# Request For Board Action

**SUBJECT:** Olsen (Glass Tinting Business) Consideration of an Annexation, Annexation Agreement, Rezoning to B-3, Special Use for PUD, and a Site Plan Review for a property located 41362 N. Route 83.

**CASE:** Olsen  
17-11

**LOCATION:** 41362 N. IL Route 83

**FRONT ELEVATION**  
 SCALE: 1/4" = 1'-0"      DATE: 9/6/17

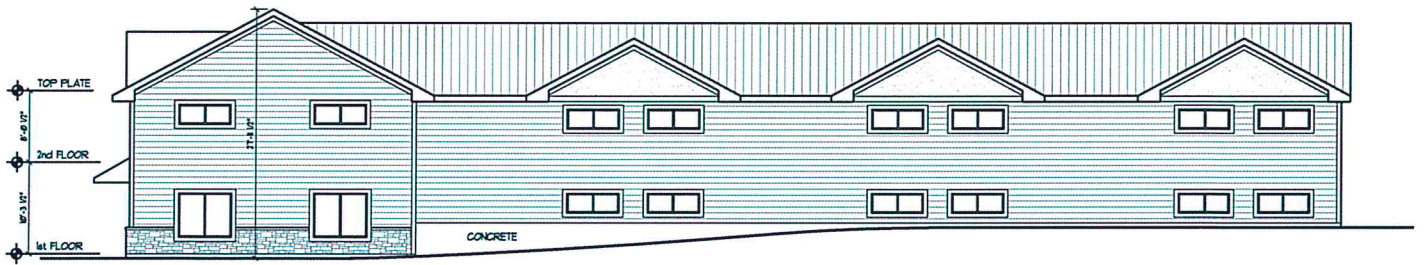
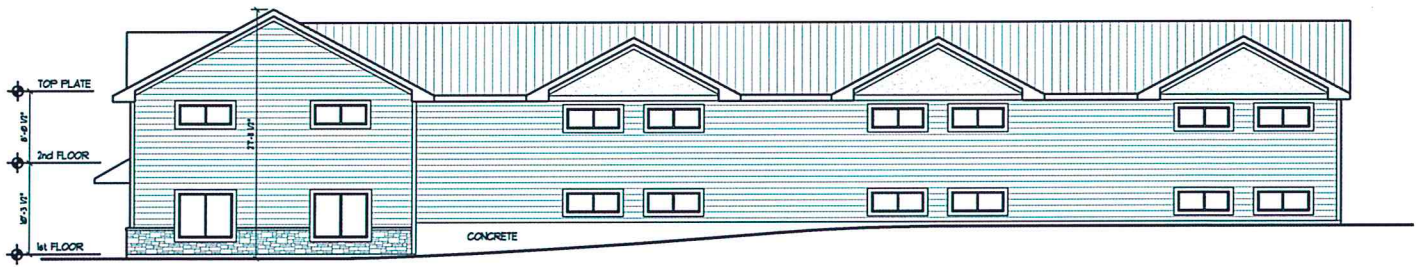
The applicant is proposing a metal structure is not consistent with the Village's Site Plan Review Ordinance. The Village's Site Plan Review Ordinance requires a predominance of quality materials including face brick, stone, or glass. Fiber cement board would also be an acceptable alternative.

The applicant has submitted revised architectural elevations that incorporate fiber cement clapboard on all four elevations and a cultured stone on the east and southern elevations. Consistent with the request of staff, additional articulation has been added to the proposed elevations. A series of gables have been incorporated into the east and southern elevations, which provides some additional articulation and movement to the structure.

SCALE: 1" = 10'  
 LANDSCAPE PLAN

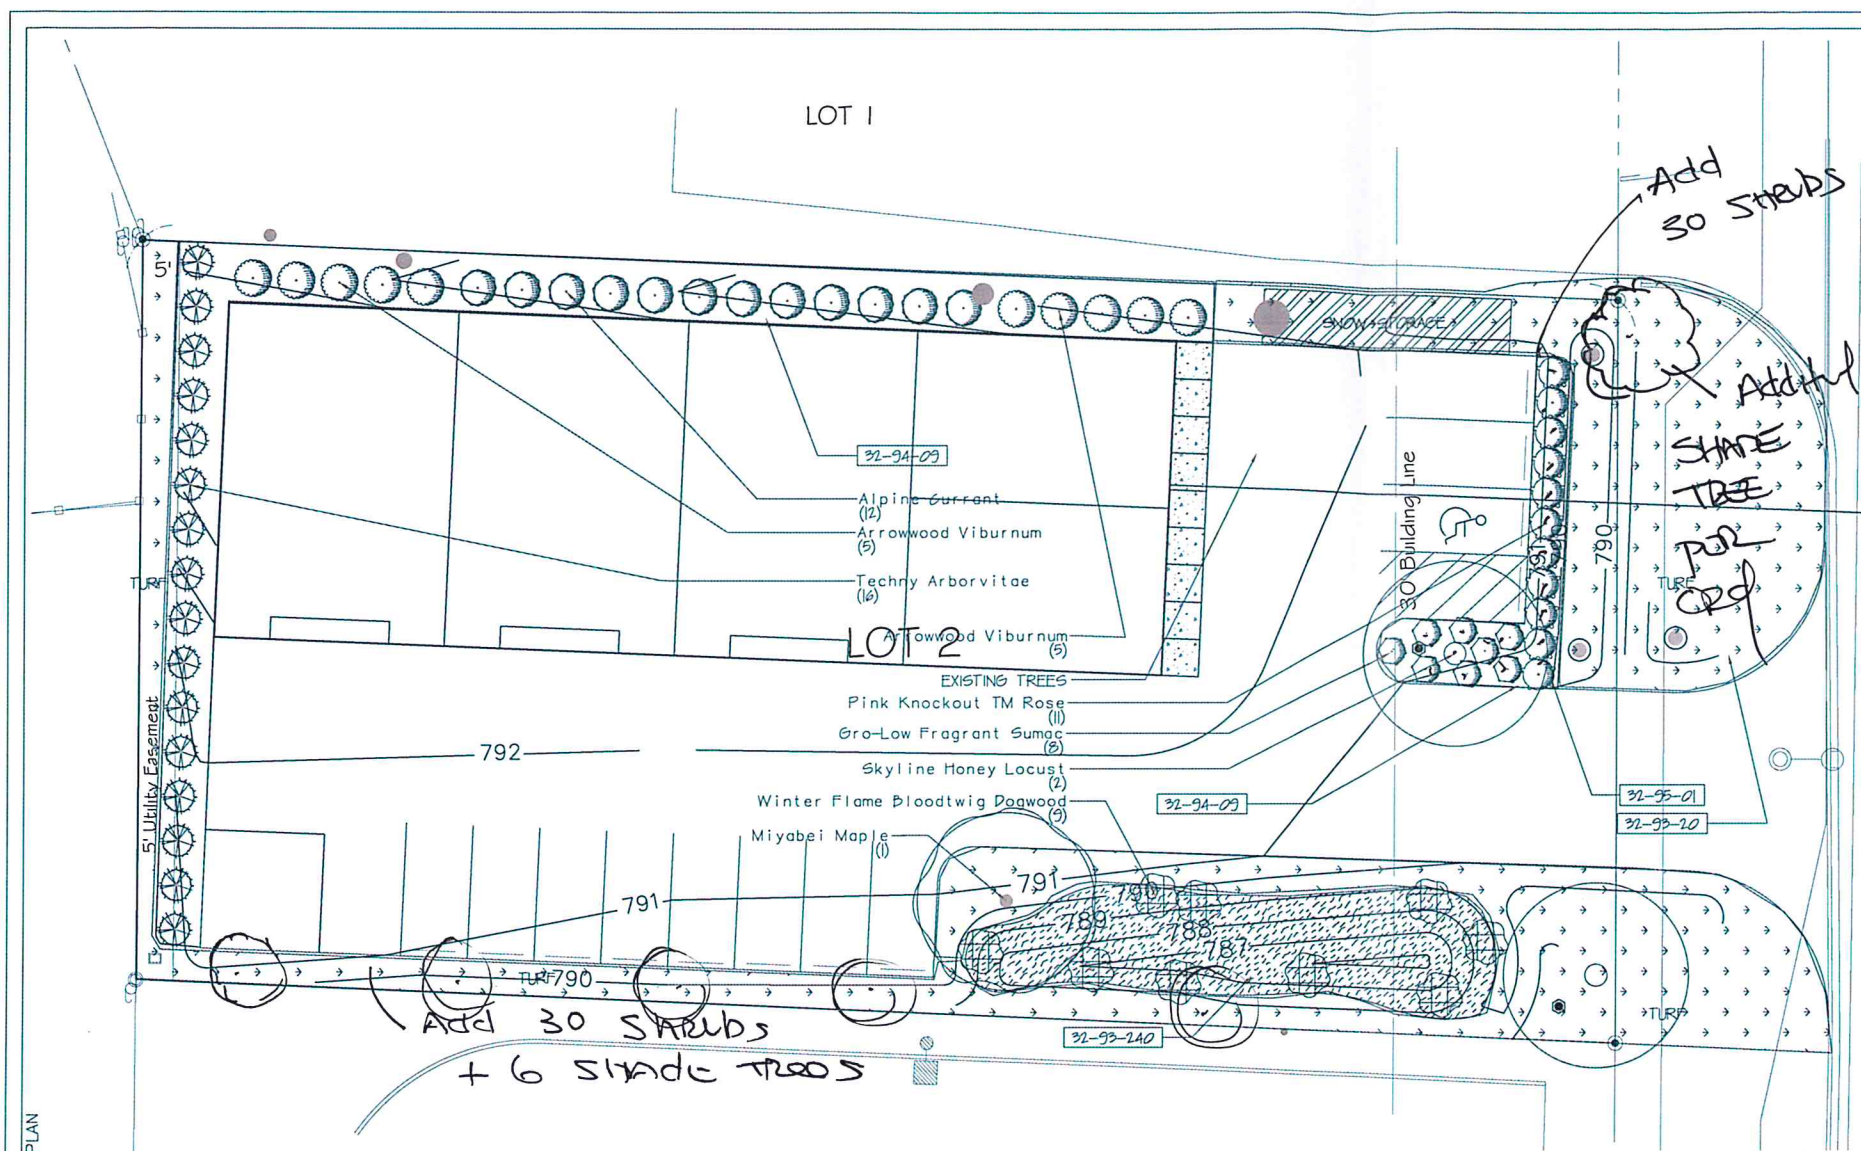
The Site Plan Review would require a total of 3 shade trees and 50 shrubs. The applicant is proposing a total of 2 shade trees and 20 shrubs. Based on the Village Ordinance, an additional shade or ornamental tree along with 30 shrubs need to be introduced to the landscape buffer along Route 83.

In addition, the applicant will be required to introduce 30 shrubs and 5 shade trees to the southern landscape buffer and an additional 6 shade trees to the northern landscape buffer.

The applicant does not have the required 40 foot rear landscape buffer that is required by the Village's Site Plan Review Ordinance. The applicant is proposing to create a landscape buffer of 100 percent opacity over time by introducing 16 arborvitae trees along the western perimeter of the site. Over time these trees will create a natural wall of vegetation which will buffer this site from the neighborhood to the west.

- 1. Compliance with the requirements of the Village Engineer.***
- 2. Compliance with the requirements of the Antioch Fire Protection District.***
- 3. Submittal of a revised landscape plan per the recommendations of staff outlined above.***
